CORRECTIVE MEASURES IMPLEMENTATION PLAN SOLID WASTE MANAGEMENT UNIT
54 WITH TRANSMITTAL AND RESPONSE TO COMMENTS NAVAL ACTIVITY PUERTO
RICO
6/1/2012
AGVIQ/CH2M HILL

RE: Contract No. N62470-08-D-1006
Task Order No. JM04
Solid Waste Management Unit (SWMU) 54
Naval Activity Puerto Rico - Ceiba, Puerto Rico
Corrective Measures Implementation Plan for SWMU 54 TCE Plume

Responses to Comments Summary	
Regulatory Comments from:	<u>Timothy R. Gordon</u> (EPA Project Coordinator), Robert Young (TechLaw, Inc.), Wilmarie Rivera (PREQB Federal Facilities Coordinator)
Document:	<i>Corrective Measures Study Addendum SWMU 54 TCE Plume and the Corrective Measures Implementation Plan SWMU 54 TCE Plume, Naval Activity Puerto Rico (NAPR), EPA ID PR2170027203, Ceiba, Puerto Rico, dated January 2012</i>
Regulatory Letter Date:	Email Dated: March 30, 2012
Response Due Date:	June 18, 2012
Response Submittal Date:	June 18, 2012

FIGURE 3-1
 Deep Well Installation Location
 SWMU 54
 Naval Activity Puerto Rico

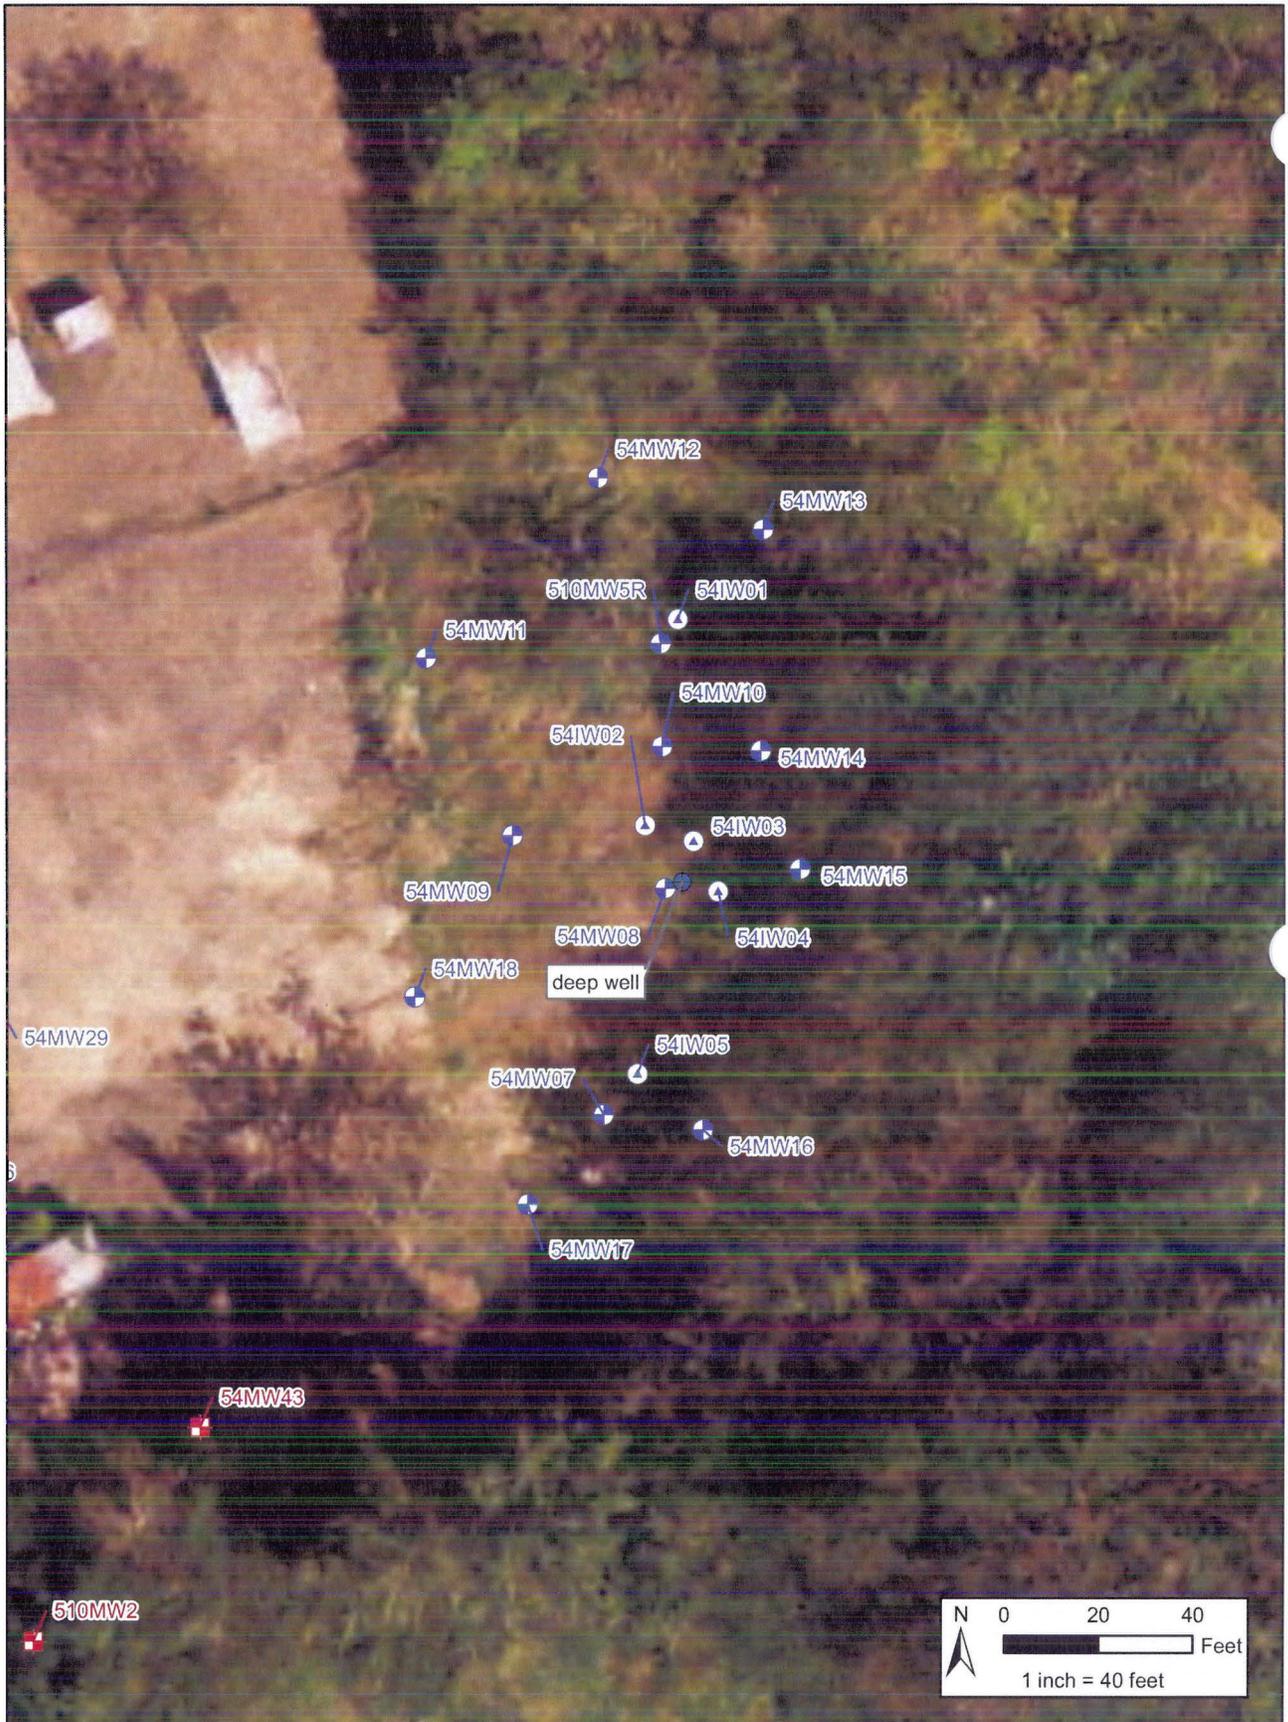
4. **Figure 3-1, ISB Injection Locations, Page 3-2:** Well 54MW16 is not included in the plume (blue area). Since the final TCE concentration (from Table 3-3 in Appendix A) was 22.8 µg/L which is greater than the CAO, this well should be included. Revise Figure 3-1 to address this discrepancy.

54MW16 is within the plume shown in Figure 2-1, showing the baseline results from the characterization phase of work. No other plume map is shown in the CMI.
